4318 STONE WAY N MIXED-USE BUILDING

4318 Stone Way N Mixed-Use Building
Project No. 3038261-LU

Design Recommendation
06/26/2023

8.0 ITEMIZED RESPONSE TO EDG

EDG STREET LEVEL PLAN
NTS

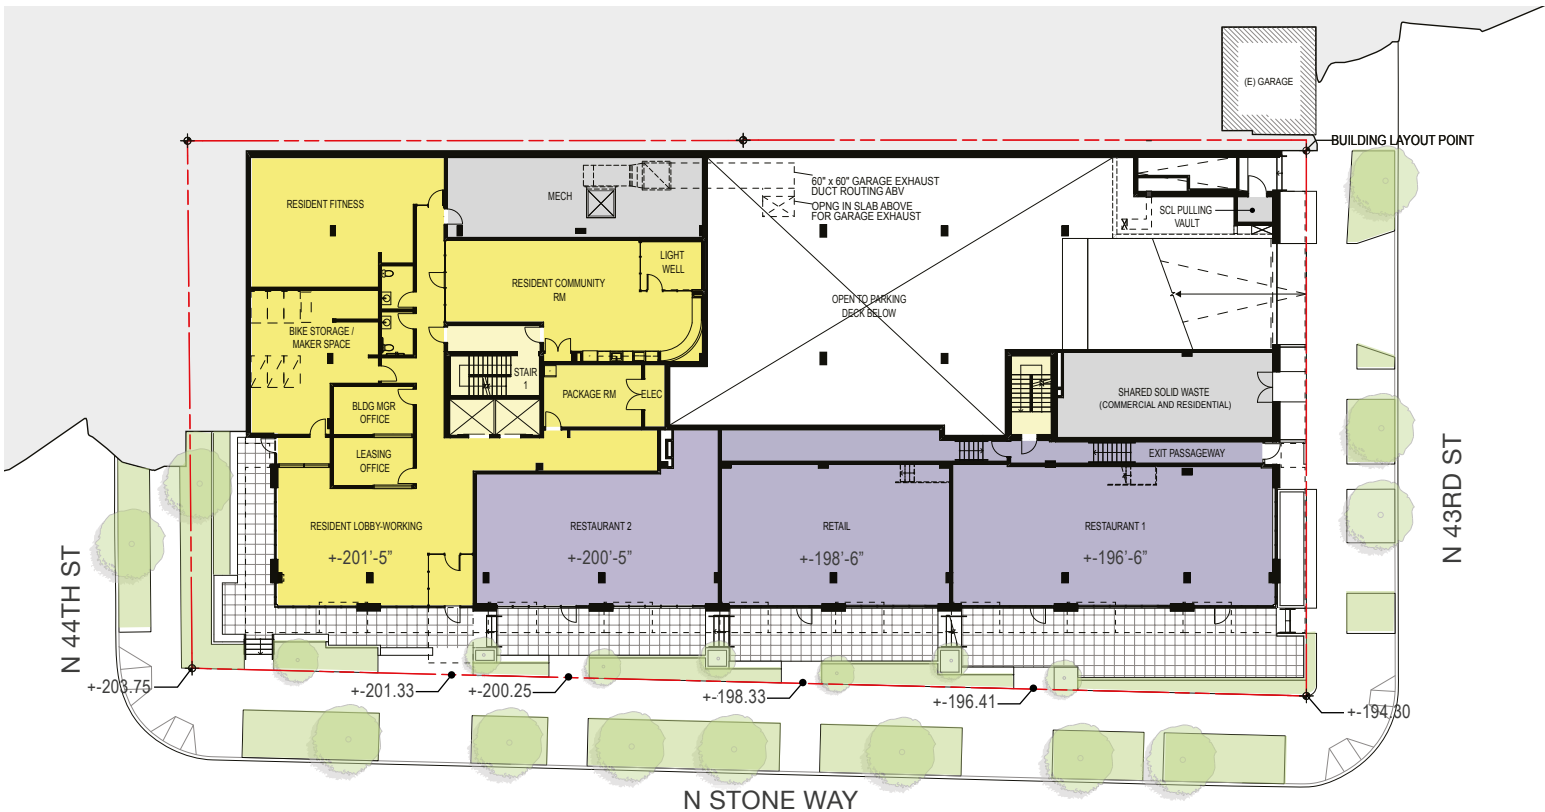
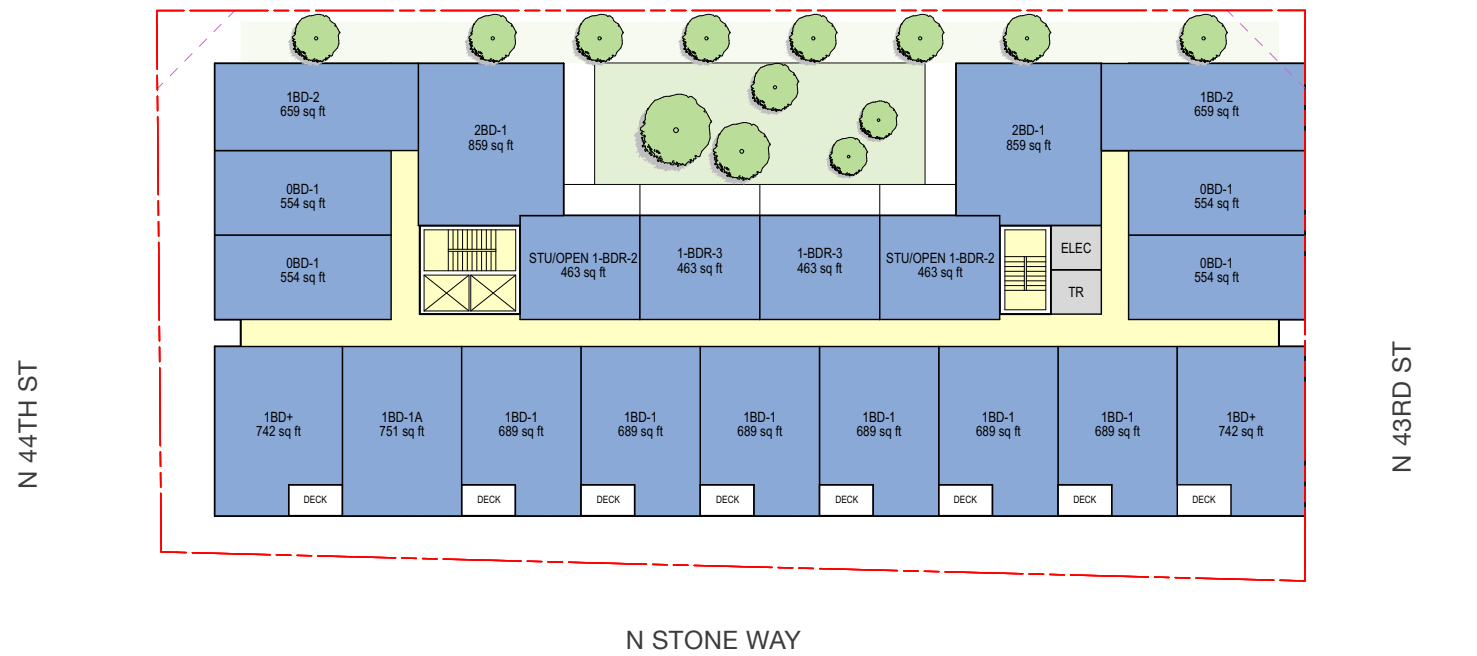
1b. Massing:

The Board supported the arrangement of the program elements—including the east facing courtyard and the restaurant at the southwest corner—considering the drastic change in topography. (PL1-C, PL2-II-iv, DC2-D-1, DC3-I-I, DC4-D-2).

The preferred massing option and site organization have been maintained as presented at Early Design Guidance with refinements. The organization of street level program along Stone Way N is informed by the topography of the site and site geometries, described on pages 12 and 13, which influence the heights of the street level spaces and the available dimension of the terraces associated with each space. The height of each street level space and terrace increase from north to south. Locating the residential entry at a corner of the site was desired from a wayfinding perspective and located at the northwest corner where the lowest street level height occurs. This also places the residential entry closer to the sidewalk thereby lessening the terrace space associated with the lobby. Conversely, the taller street level spaces and generous terraces are reserved for commercial uses. Please refer to the street level plan on page 30 for terrace dimensions.

The east-facing courtyard presented at Early Design Guidance has been further developed. This space is intended to function primarily as a buffer between building residents and the neighbors to the east. The courtyard provides access to daylight and natural ventilation for the units fronting it, structures privacies to and from the neighboring parcels, and reduces shadows in the rear yards of the neighbors. Please refer to sections and elevations on page 21 which illustrate the spacial relationship between the proposed building, courtyard and the neighboring parcels and existing single-family homes to the east.

SECTION A-A AT EAST COURTYARD
NTS

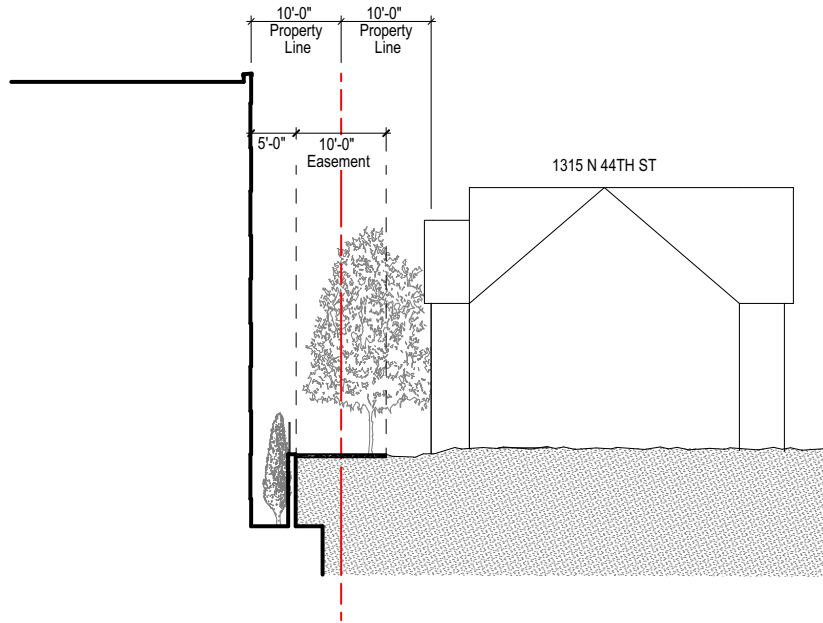
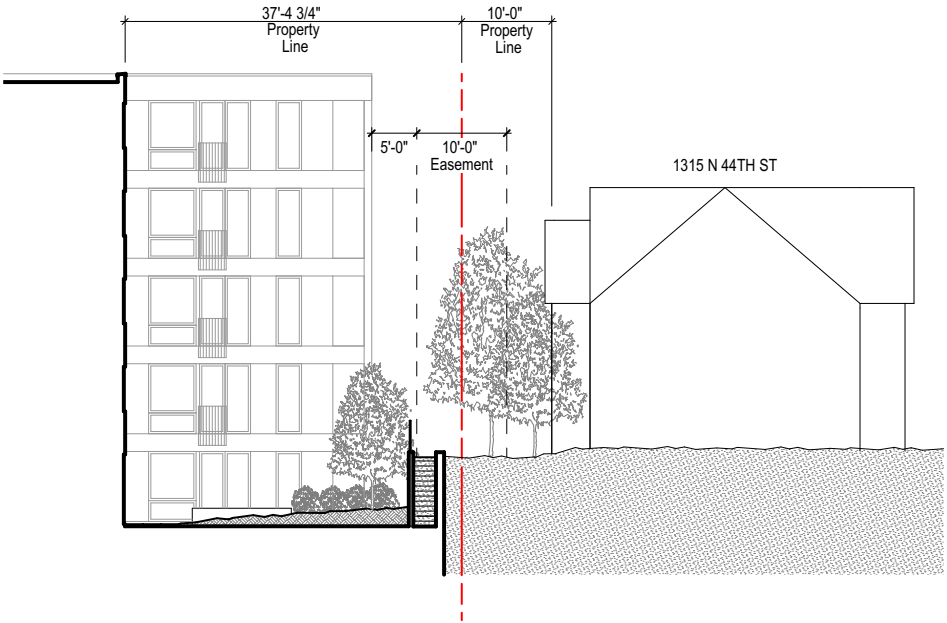
The Board added that the courtyard is a positive attribute as it allows for access to light and air for the adjacent properties. However, the Board did ask for additional clarification on the design of the courtyard in terms of how it functions, its elevational relationship to adjacent properties, the relationship to the façade and balconies, and who the users might be. (CS2-D-2 PL1-C, PL2-II-iv, DC2-D-1, DC3-I-I, DC4-D-2).

The Board stated that it would be helpful to see more sections at the east façade of the building in the Recommendation packet. This information should include dimensional clarity, including distances from adjacent residential buildings, and indicate how the elevations between buildings and windows might relate to each other. (CS1-B-2, CS2-B, CS2-D-3, DC4-II)

The Board generally supported the overall east building façade but stated that they would like to have a better sense of what is occurring along the building’s eastern edge and how the open courtyard up above functions and relates to the rest of the landscaping elements. (CS2-C-3, PL2-II-I, DC2-B)

As noted in response to the prior comment, the courtyard has been maintained and serves the purpose of allowing access to light and air for the building residents and neighbors. Functionally, the courtyard will be a passive space with access limited to only those units fronting it at the second level. Larger functions will make use of the roof terrace located at the western side of the building. The limited activity and lush landscaping of the courtyard will minimize noise, while the width of the courtyard and its lower elevation will establish privacy with the neighbors to the east.

The eastern elevation abuts two existing structures and needs to mediate privacy concerns. The units located along its width are oriented either to the courtyard or to the adjacent streets—N 44th Street to the north and N 43rd Street to the south. This façade is setback 10-ft from the east property line, which coupled with the existing setbacks of the neighboring structures results in a separation of 18.5-ft at the south and 20-ft at the north, please refer to sections B-B and C-C on page 21. As illustrated in section A-A on page 21, windows along the eastern elevation have been minimized and their locations determined with sight lines in mind.

RESIDENTIAL ENTRY AT EDG NORTHWEST CORNER
NTS

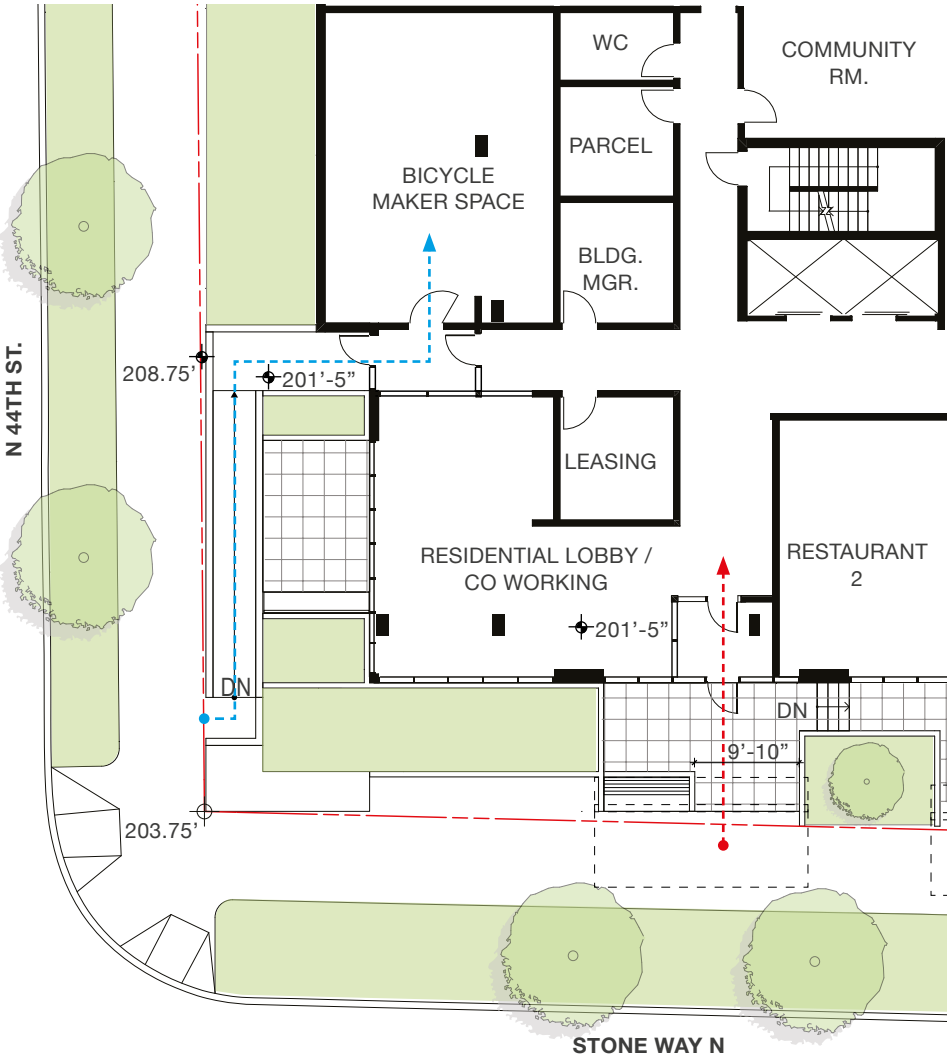
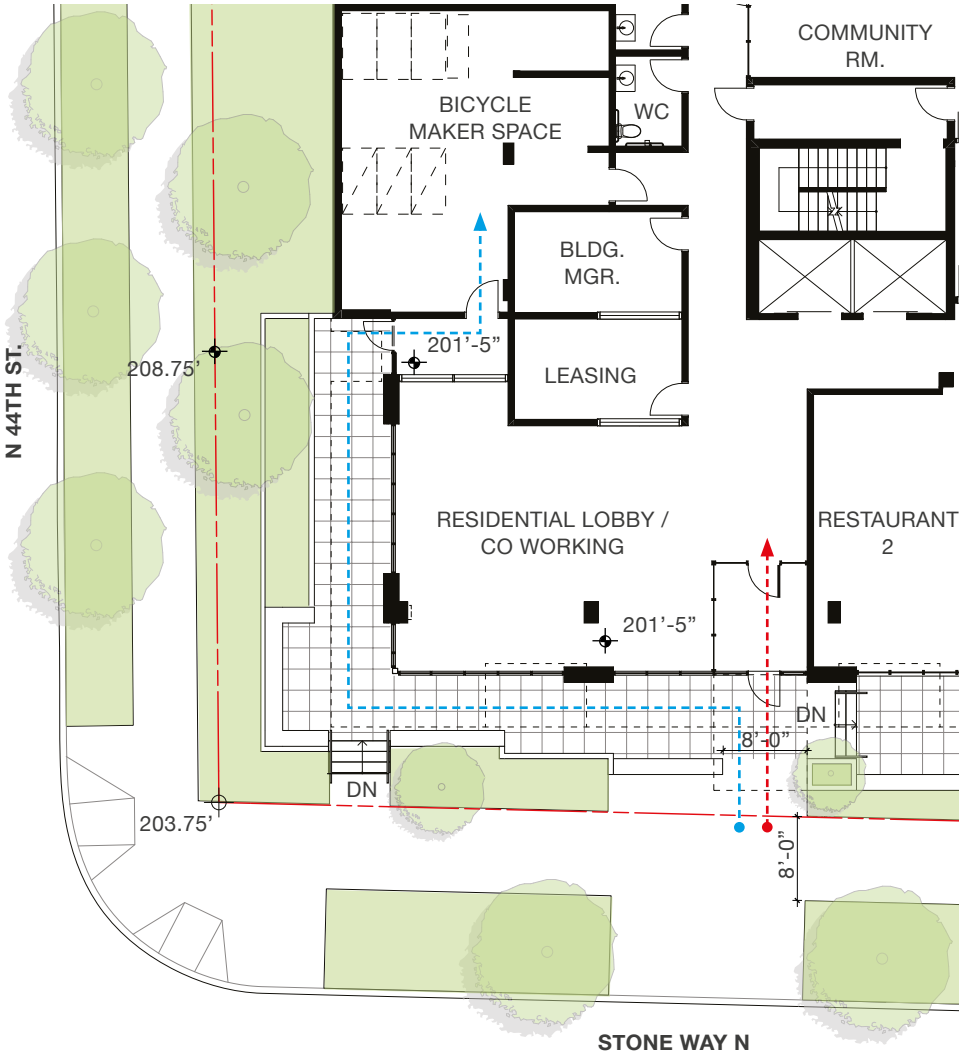
The Board verbalized that they did not necessarily understand the design approach to the northwest corner, although they assumed it relates directly to the change in grade. (CS1-C, DC4-B-1).

Regarding the building's northwest corner and bicycle ramp, the Board suggested that the residential entry should ideally be located closer to the corner. However, if that it is not feasible from a grading standpoint, then there needs to be some sort of framing that creates a separation and buffer between the ramp and residential entry that is clearly visible and welcoming. (DC2-D-1, DC2-I-iii).

In response to the Board's recommendation at Early Design Guidance, the organization of the streetscape design at the northwest corner has been revised to eliminate bicycle ramp and more clearly emphasize the residential entry. Bicycle access is still provided using the same approach from Stone Way N as the residential entry.

The residential lobby and entry are proposed at the northwest corner of the building. The main entry is located approximately 45-ft from the property corner and 33-ft south of the building's northern extents due to the site's topography. This location allows for at-grade access while achieving a 12.5-ft floor-to-floor that maintains the datum established at the building's base. The location of the residential entry is subtly indicated in the organization of the residential levels allowing the building to be read from afar. A large, cantilevered canopy marks the entry location more directly.

EDG OVERHEAD WEATHER PROTECTION

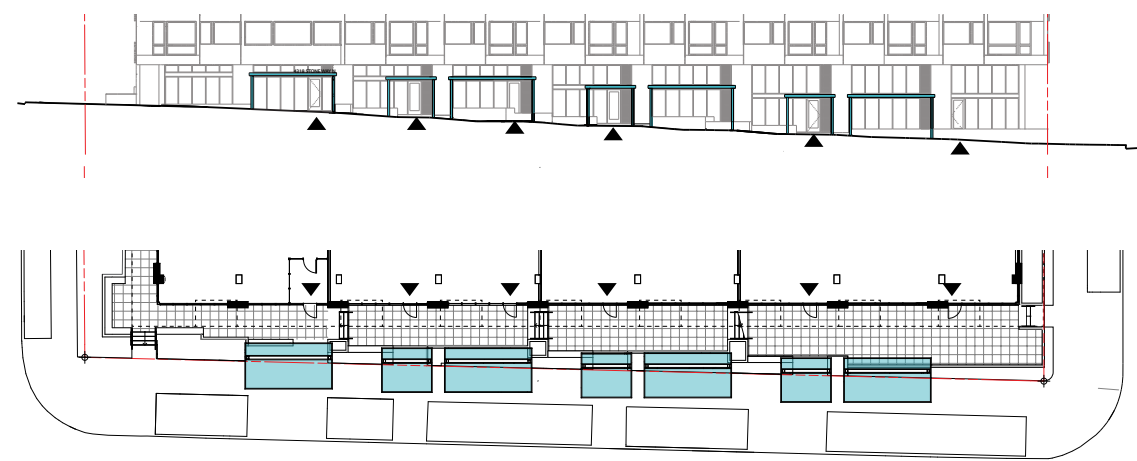
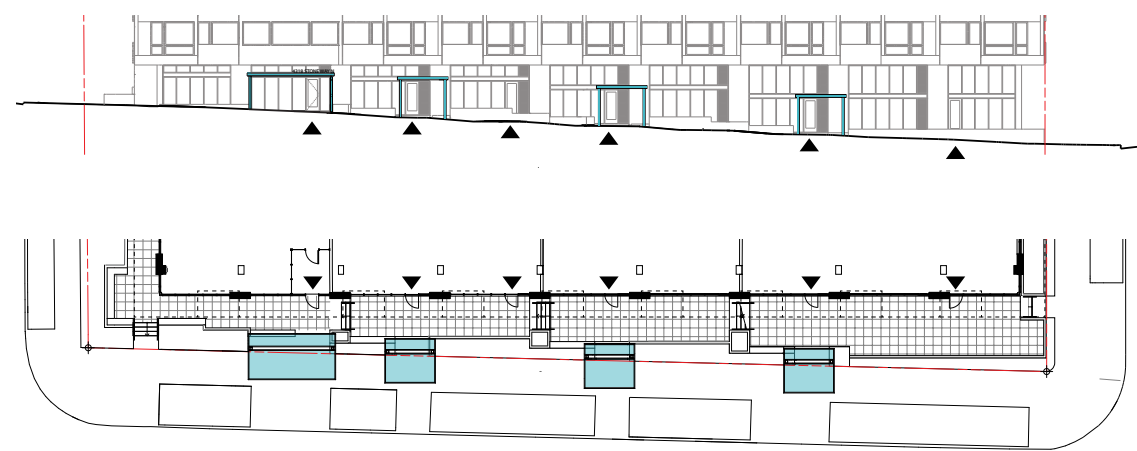
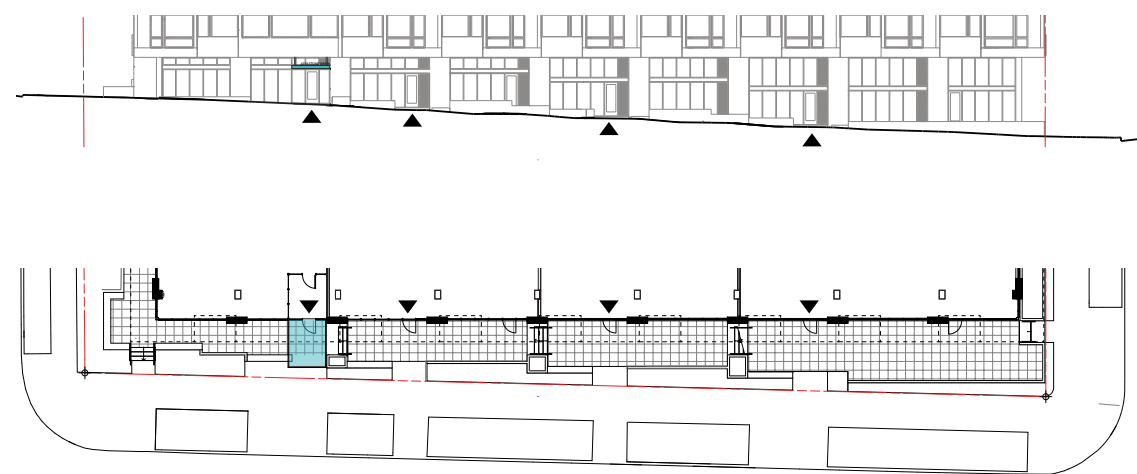
In response to public comment, the Board asked how the placement of canopies for weather protection relates to the rhythm of the balconies and the massing of the building. The Board suggested that the canopies should not be located over planting areas. The Board also was concerned that the overhead weather protection as proposed might relate better to the location of the entries, rather than provide continuous across face of the building. (CS2-II, PL2-C, PL2-I-ii).

The Board stated that they would like to see more information in the Recommendation packet on how the overhead weather protection relates to the massing moves above, as well as the overall architectural concept, and not just to the changes in grade. The Board also stated that they would be in favor of a departure request from the amount of overhead weather protection, if necessary to establish a better rhythm and connect to the architectural moves overhead. (CS2-II, PL2-C, PL2-I-ii).

Overhead weather protection is proposed to be provided primarily by the continuous building overhang that runs the length of the building along Stone Way N. Additional overhead weather protection is proposed at the main residential entry with a cantilevered canopy, and a smaller overhang at each of the commercial entries along Stone Way N to better identify the entries to each. The latter are sized and located to correspond with the rhythm of the storefront and articulation of the building base along Stone Way N.

The proposed approach scales back earlier proposals to provide overhead weather protection at the sidewalk and instead provides a continuous protected pathway inboard the site. This requires departures, please see Departure Requests 4, 5 and 6 as well as dimensioned plans and sections on page 63ff.
